SHAPING THE PARKWAY

TOWN COUNCIL – RECOMMENDATIONS FOR PREFERRED LOCAL POSITION

HILTON HEAD ISLAND // 10.12.2021

BRIDGE SECTION - LOCAL ALTERNATIVE

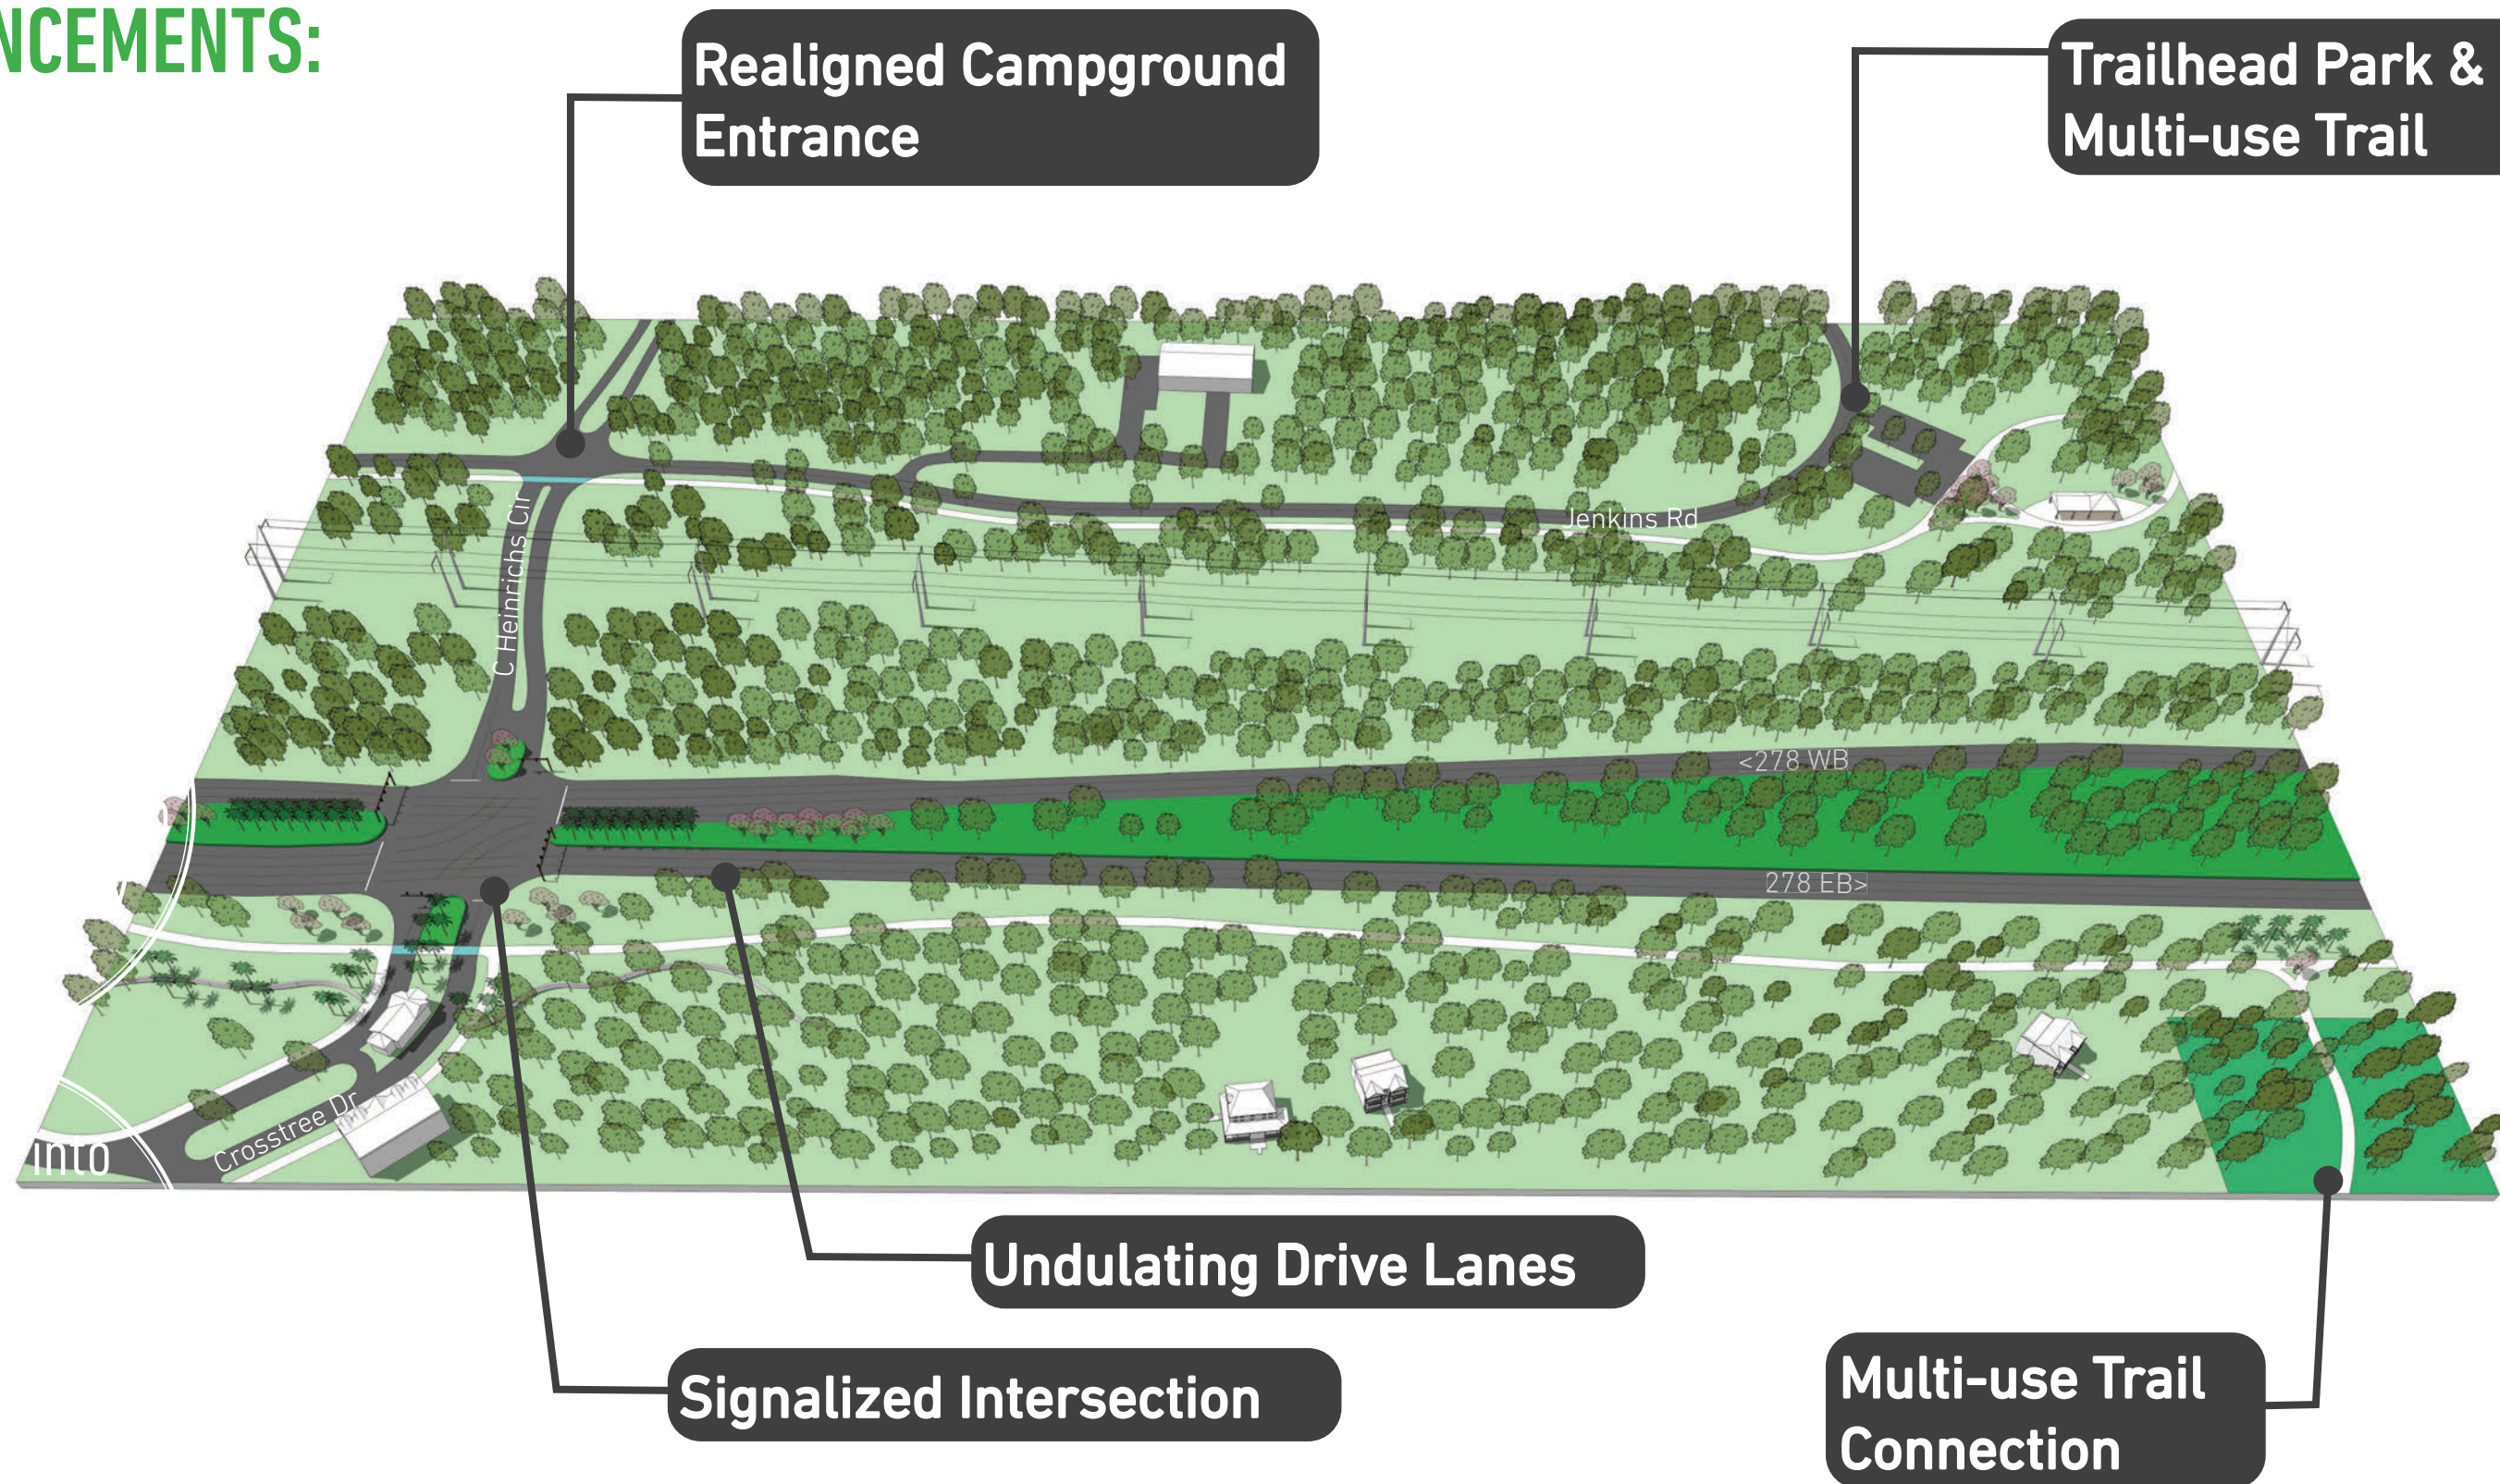
1. **Reduce bridge mass with two separate bridges and Shared-Use Path on south side of eastbound bridge**
2. **Reduce bridge lane width to 11', reduce shoulder width on left, only one breakdown lane on right**
3. **Provide 14' minimum width non-motorized lane on bridge with multiple viewing areas and protection/screening of vehicles**
4. **Attention to bridge design/details as viewed from afar and on-deck** (parapet, railings, structural forms)

WINDMILL HARBOUR INTERSECTION

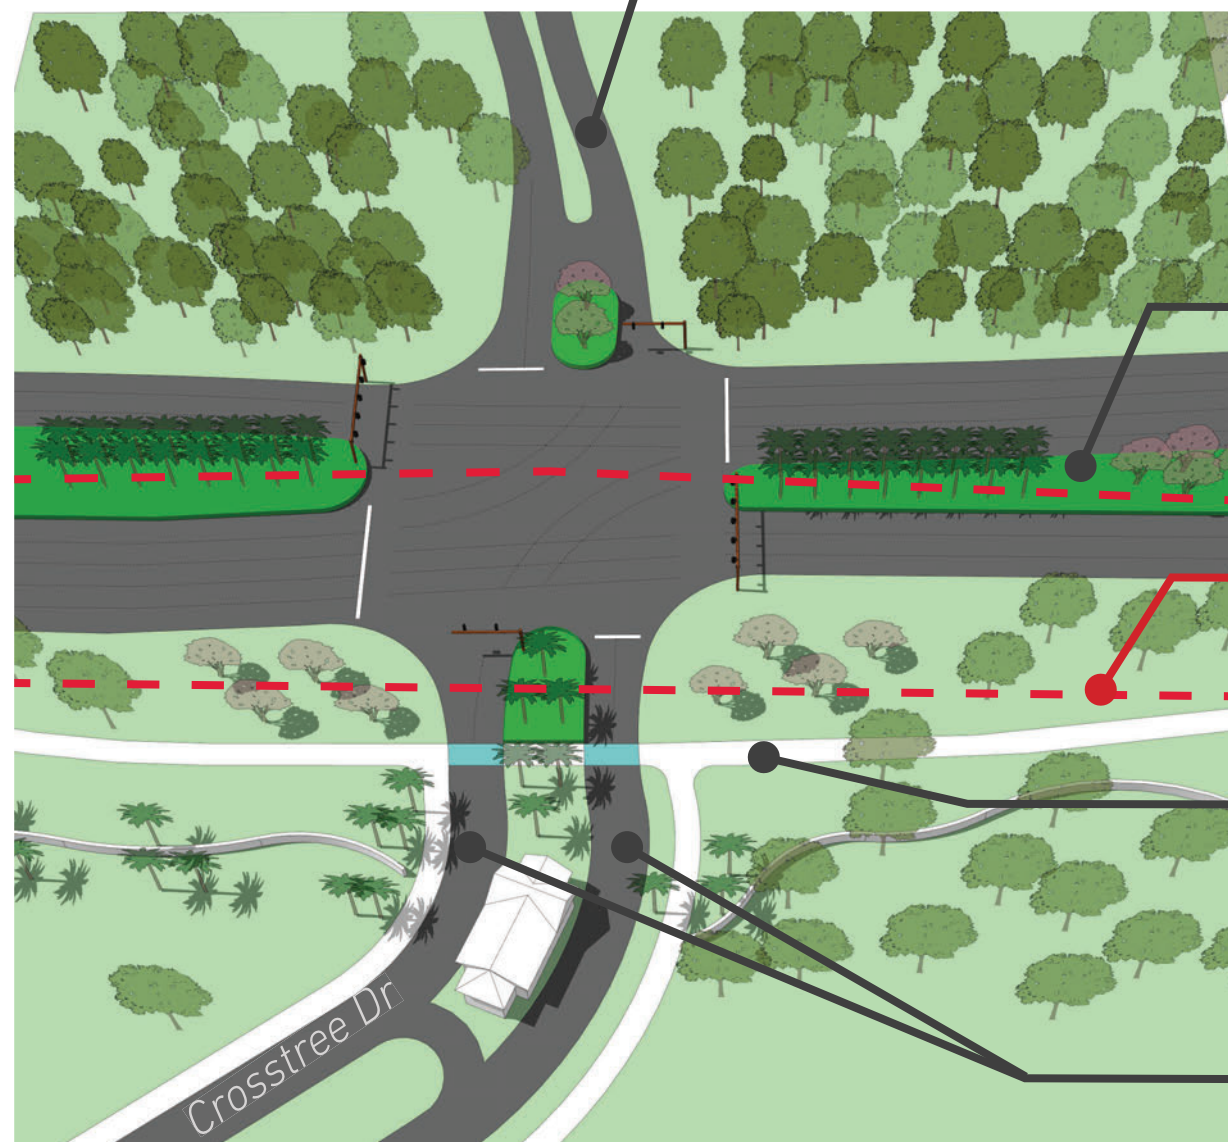
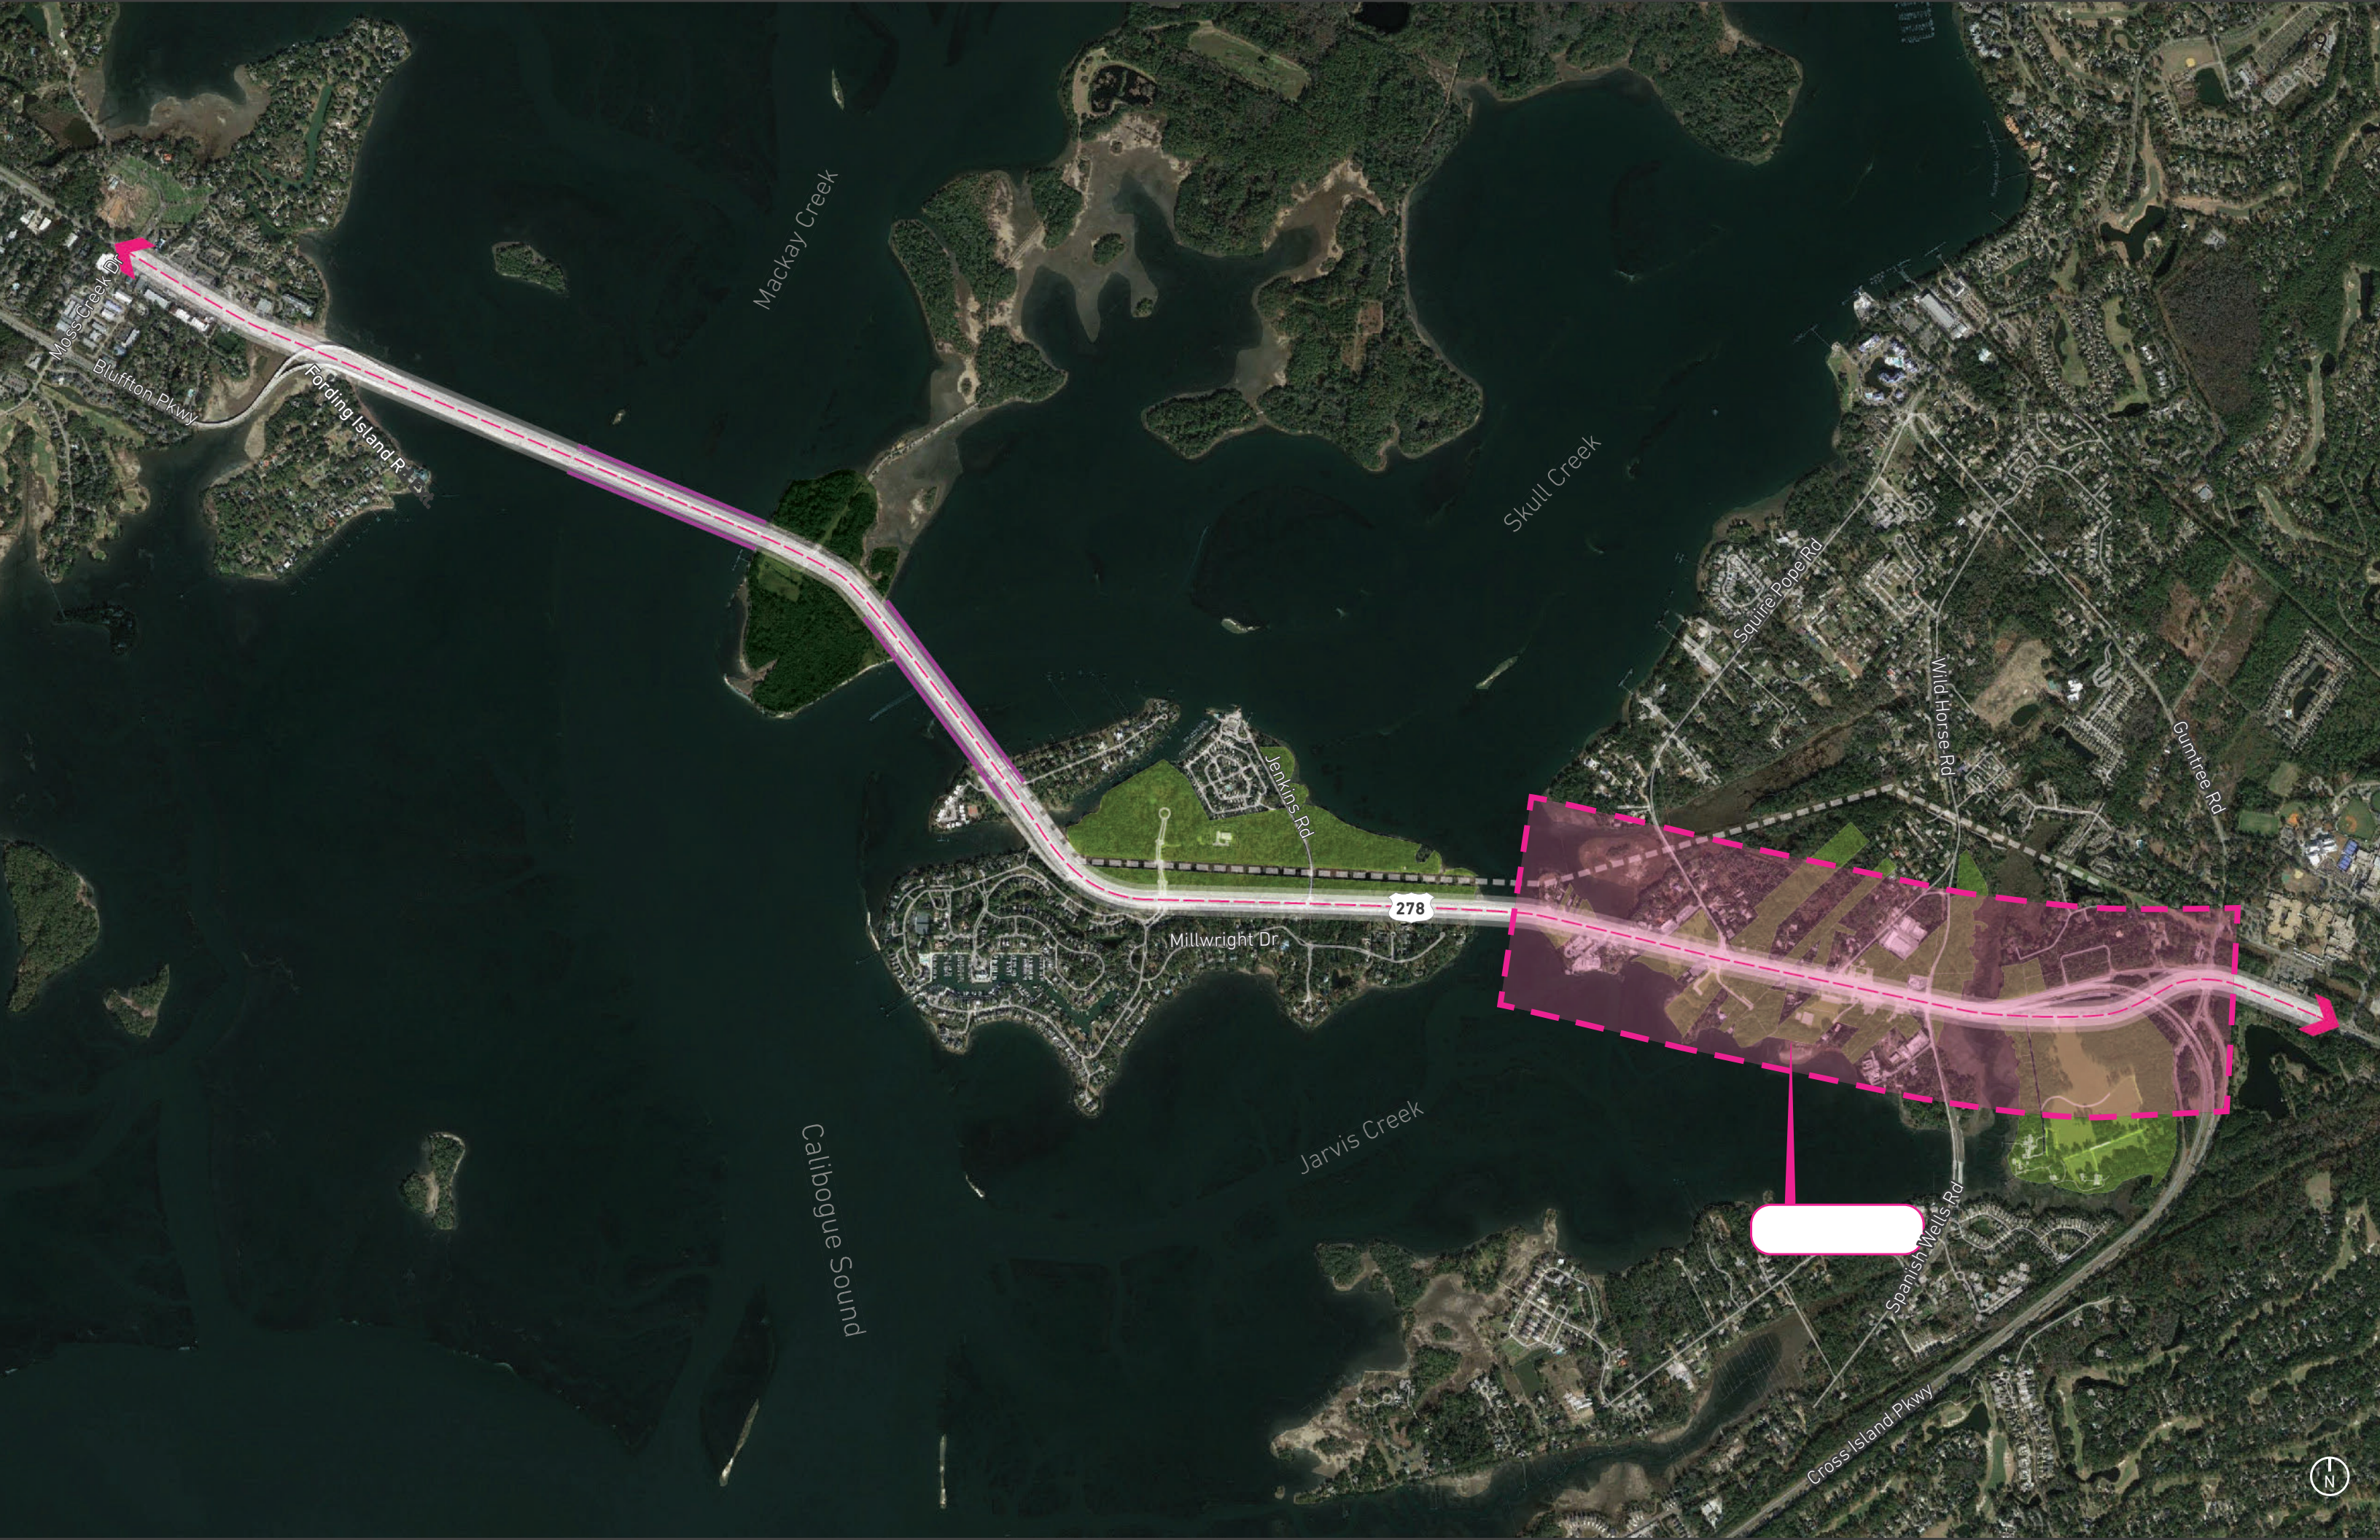
Shift intersection north to allow more stacking through Windmill Harbour gatehouse

Consolidated access to north

Widened Median & Enhanced Landscape

No crosswalks at traffic signal
- separate connection to new trails system
